### 3.2.4 Groundwater

## 4. GOVERNMENT AGENCY SUBMISSIONS

## 4.2 DEPARTMENT OF ENVIRONMENT, CLIMATE CHANGE AND WATER

Figure 3 Surface Water Quality Results

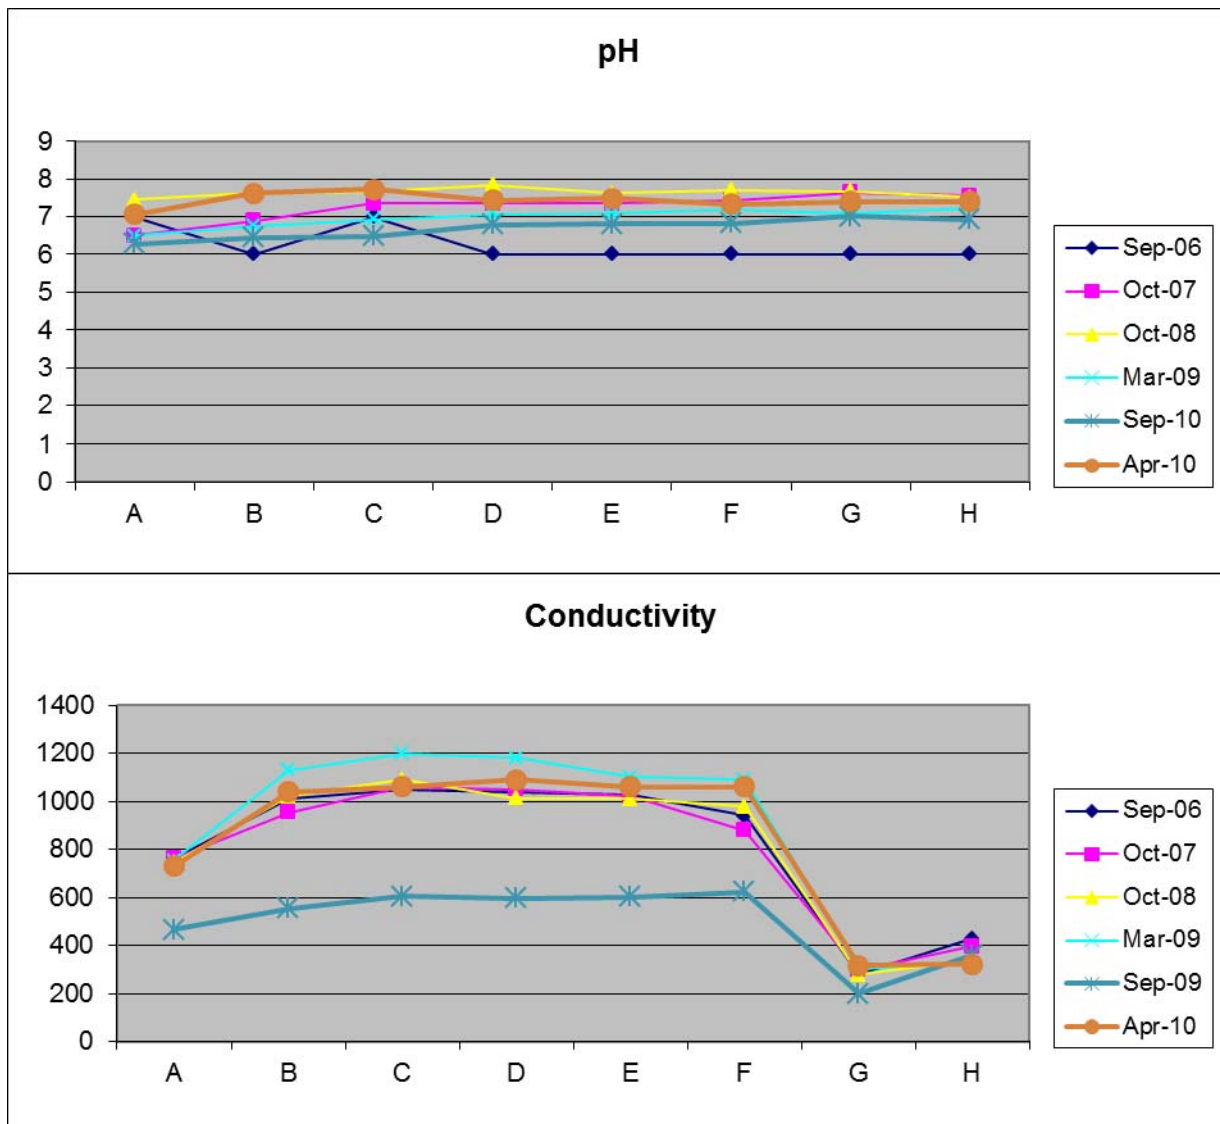
- The electrical conductivity of surface water within Majors Creek is typically between 200 $\mu$ S/cm and 400 $\mu$ S/cm. These results indicate that electrical conductivities within Majors Creek are at the upper end or exceed the ANZECC (2000) water quality guidelines for upland rivers of 30-350 $\mu$ S/cm.

Given that electrical conductivities of water within Spring Creek significantly exceed the ANZECC (2000) guidelines and that water within Majors Creek is at the upper end or exceed those guidelines, the Proponent contends that the proposed compensatory release program does not “represent a real risk to downstream water quality and the users of this water” for the following reasons.

It is noted that water to be released to Majors Creek through the compensatory flow program would be sourced principally from the harvestable rights dams and that water quality within those dams is likely to be within the relevant ANZECC (2000). It is also noted that the surface water modelling identified that based on a maximum rate of release of 66.2ML per year, 100 years of rainfall data and a range of conservative assumptions, that the harvestable rights dams could provide sufficient water for the compensatory release program on 97% of all days modelled.

As indicated in Section 2.10.2.6 of the *Environmental Assessment*, the Proponent would, if required, source water for the from the historic Snobs, United Miners or Stuart and Mertons workings for compensatory flows should the harvestable rights dams not be able to provide the required water. Table 4.19 of the *Environmental Assessment* provides an overview of the quality of water within the monitoring bores constructed for the groundwater assessment.

- The compensatory flow program is designed to compensate for reduced groundwater discharge to Spring and Majors Creeks. Table 4.19 of the *Environmental Assessment* identifies the quality of groundwater within the Project Site. In summary, water within the granodiorite aquifer typically has electrical conductivities in the range of 530 $\mu$ S/cm to 1 300 $\mu$ S/cm.

- Water within the harvestable rights dams would be likely to have electrical conductivities significantly lower those measured in groundwater within the Project Site. As a result, the compensatory flow program would result in improved water quality within Majors Creek.
- In the unlikely event that water would be required to be drawn from the historic workings for the compensatory flow program, the quality of the water that would be discharged would be equivalent to the quality of the water that the program is designed to replace. As a result, the program would result in a negligible change in groundwater quality within Majors Creek.
